RM3063 – Peter Barnes – 2 Akatore Road – Response to Further Information Request

Receipt of Resource Consent Application- RM3063 – P Barnes – 2 Akatore Road, Taieri Mouth

TO:	Owners - 2 Akatore Road	Job No.:	842
ATTENTION:	Peter Barnes	Date:	6 August 2024
FROM:	Emma Burford	Page:	1 of 13
SUBJECT:	2 Akatore Rd - Onsite Wastewater Feasibility	Reference:	MM 24-08-01 EB 000842(RevA)

Figure 1: Mapped Extent of Coutts Gully Swamp.

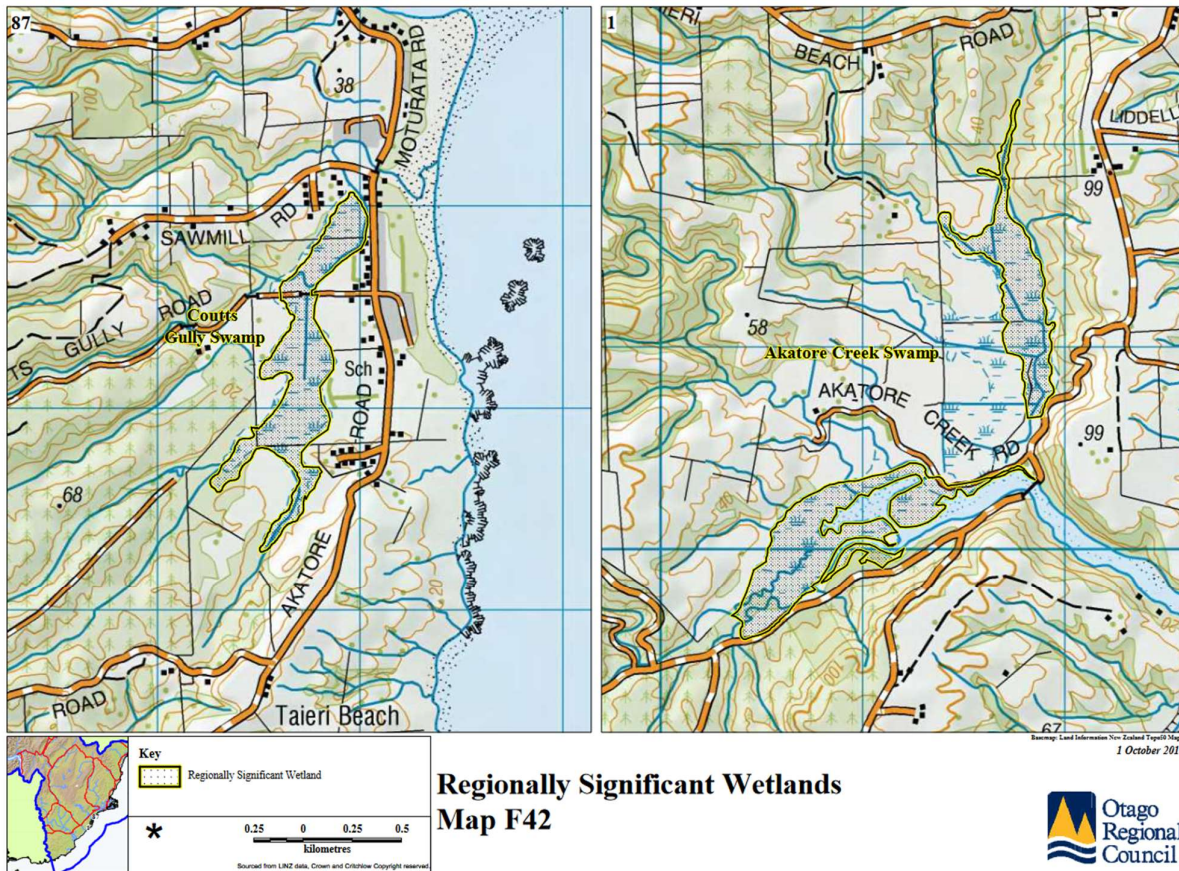
1. The Wetlands identified as being 90-105 metres from the boundaries of proposed Lot 3 and Lot 4, and within the boundaries of Proposed Lot 1 is classified as a Significant Wetland (H135) under the Clutha District Plan.

A greater understanding is necessary of whether the activity could adversely affect the wetland, including activities such as earthworks for accessways required to implement the subdivision works or other earthworks activities reasonable anticipated as part of future residential activity on the proposed lots. It is acknowledged that the National Environmental Standards for Freshwater are administered by the Otago Regional Council, however, as noted above a greater understanding of potential adverse effects on the wetland, which is identified in the District Plan as a significant wetland is required.

Clause 3.22 sets out changes regional councils must make to their regional plans whilst clause 3.23 details the mapping exercise regional councils must undertake in relation to inland wetlands. The *Regional Plan Water for Otago* includes the mapped extent of Coutts Gully Swamp as shown in Figure 1 below.

PROJECT REF.	CLS468	SHEET SIZE	A3	SCALE	1:2000
DRAWN DATE	8 AUGUST 2024	PLAN REF.			
SHEET NO.	SHEET 1 OF 2	PLAN REF.	CLS468-2B

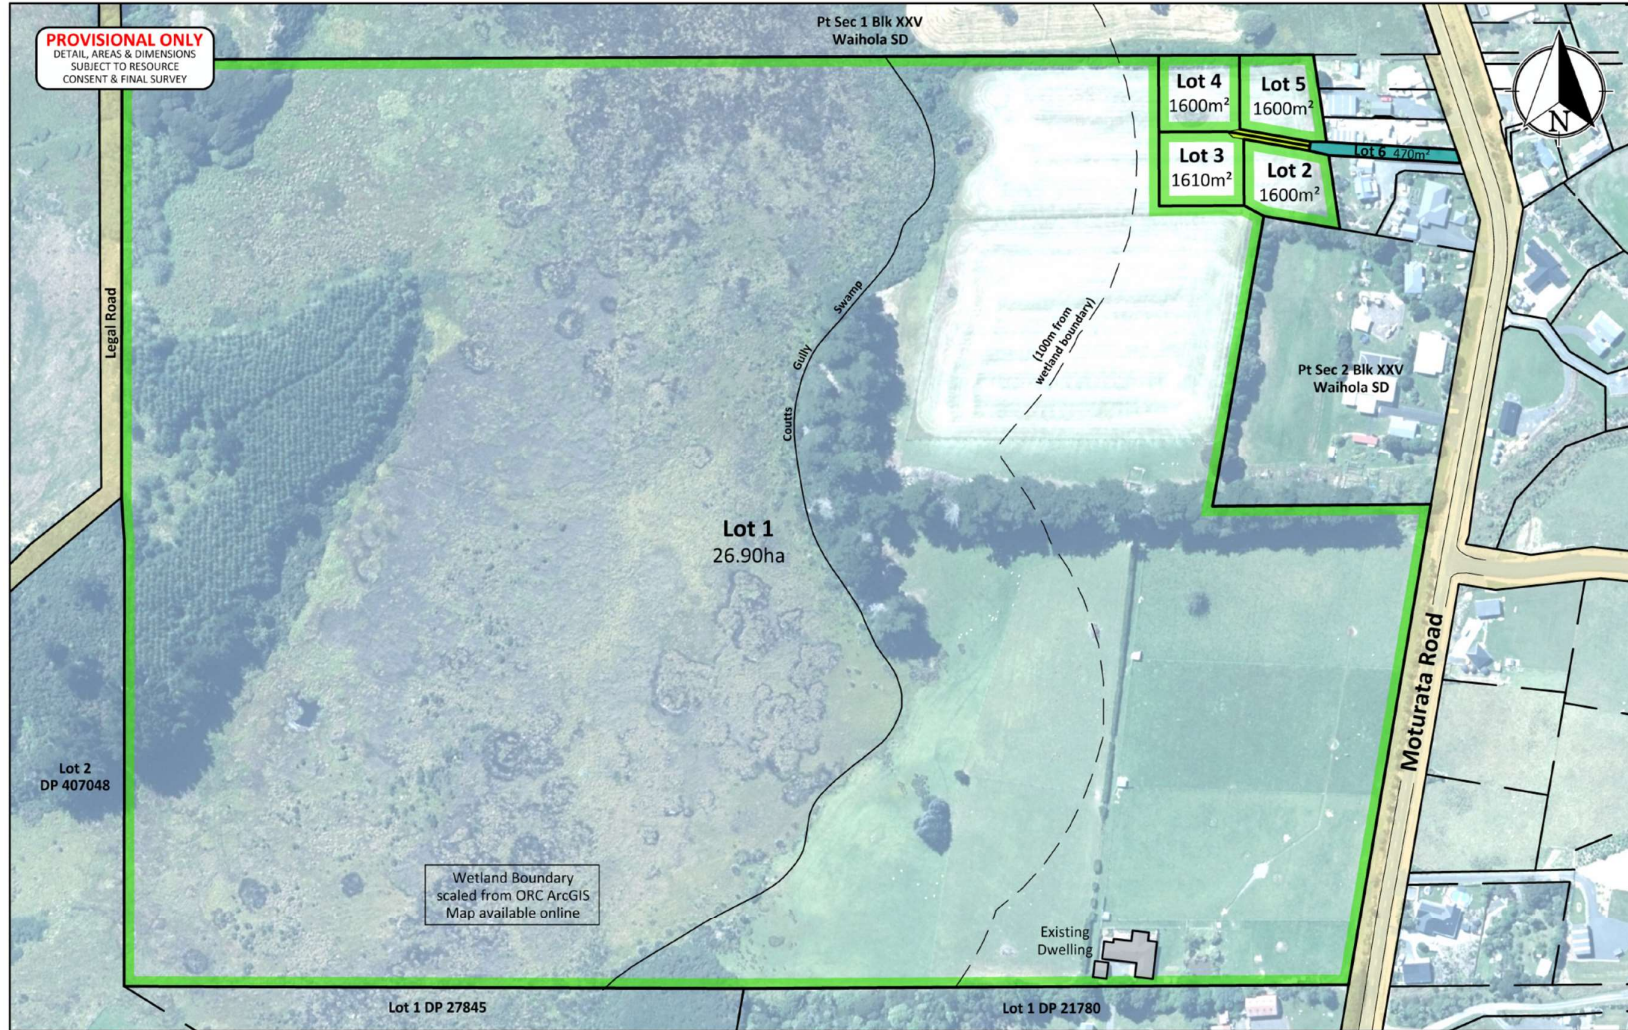
3. No sight distance measurements have been supplied to determine Site Stopping Distance for the proposed entrance. In particular the access strip exit sight distance to the right (from the south) needs to be confirmed. Please confirm the sight distance from the proposed access.

Further to this, please provide an amended Scheme Plan that reflects the updated condition.

“The site stopping distances were measured on-site, and these have been added to the plan. The SSD looking south is 75.7m based on current occupation of the area. If the neighbour were to fence all the way to their boundary, the SSD would reduce to 66.5m

at the worst case. Speed limit is 50km/h.

The SSD looking north is just shy of 180m, but with the removal of a roadside toetoe bush this would increase to probably about 300m."

Mr Scott Cookson, Registered Surveyor, has included the amalgamation condition suggested by LINZ on the updated subdivision scheme plan appended at Appendix 3.

PROJECT REF. CLS468	SHEET SIZE A3	SCALE 1:500
DRAWN DATE 8 AUGUST 2024	PLAN REF.	
SHEET NO. SHEET 2 OF 2	CLS468-2B

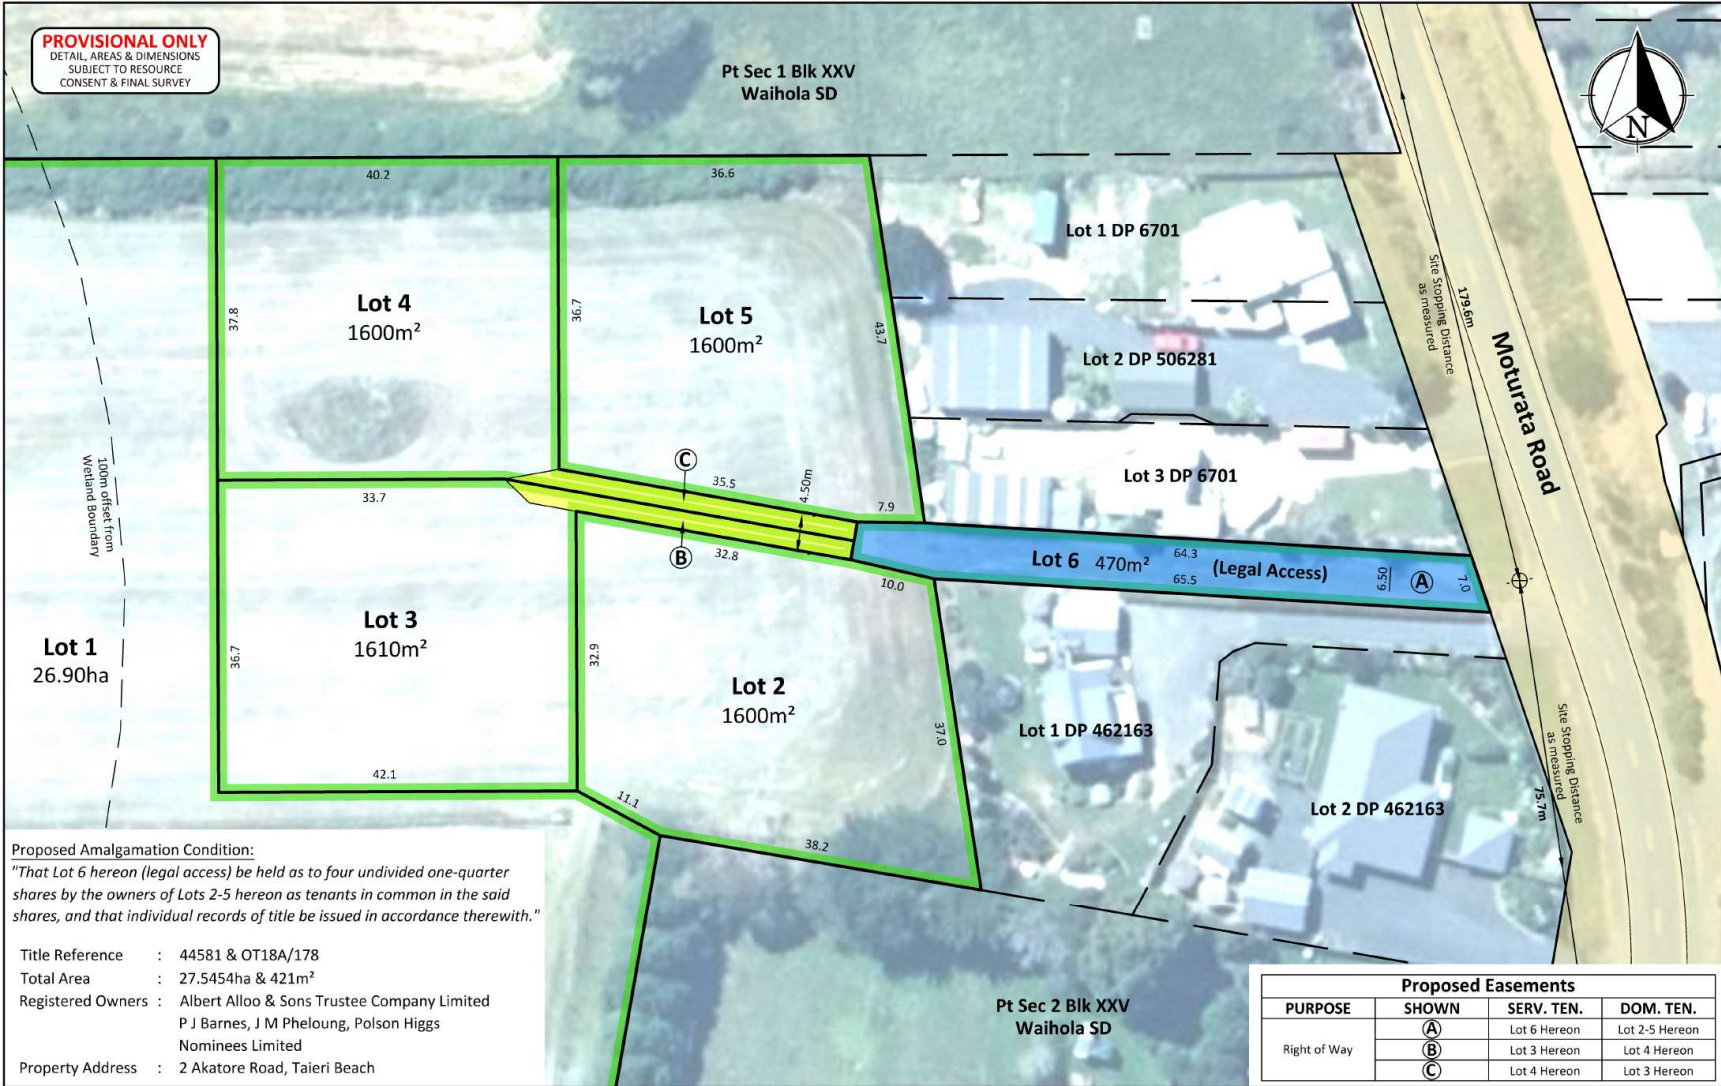
4. Land Information New Zealand (LINZ) have advised the proposed amalgamation condition wording is not practicable as not all the ¼ shares in Lot 6 have been accounted for. LINZ have suggested it would be practicable if the wording was changed to:

Proposed Amalgamation Condition:
"That Lot 6 hereon (legal access) be held as to four undivided one-quarter shares by the owners of Lots 2-5 hereon as tenants in common in the said shares, and that individual records of title be issued in accordance therewith."
